Hanlon Elementary School Building Project

School Building Committee

01.22.2021

Value Management: Review Assignments

2. (\$106,100) Eliminate roof screens

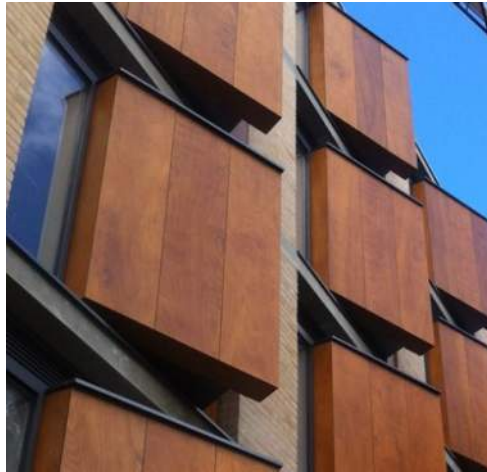
With roof screen

Without roof screen

2.(\$75,000) Eliminate roof screens	Accept credit	\$106,100	
3.(\$287,452) Change rainscreen system to Terracotta shingles	Accept credit	\$326,400	
4.(\$384,450) Entry walkway canopy : Simplify, reduce size	Not accepted

3. (\$326,400) Change rainscreen system to Terracotta shingles

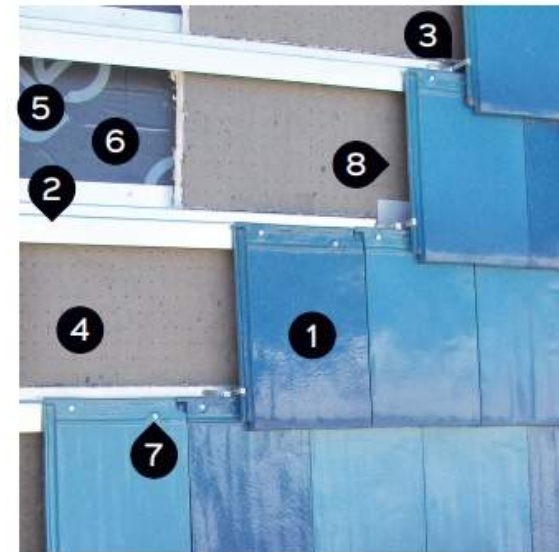
TERRACOTTA PANEL ATTRIBUTES

- ◆ Warm, all-natural material provides superior aesthetics
- ◆ Variety of colors, textures, and sizes
- ◆ Color permanent façade
- ◆ Class A fire rated
- ◆ Sustainable material that will last 100 years
- ◆ Maintenance free

75-year warranty including color

Rainscreen NeXclad System

Proposed product
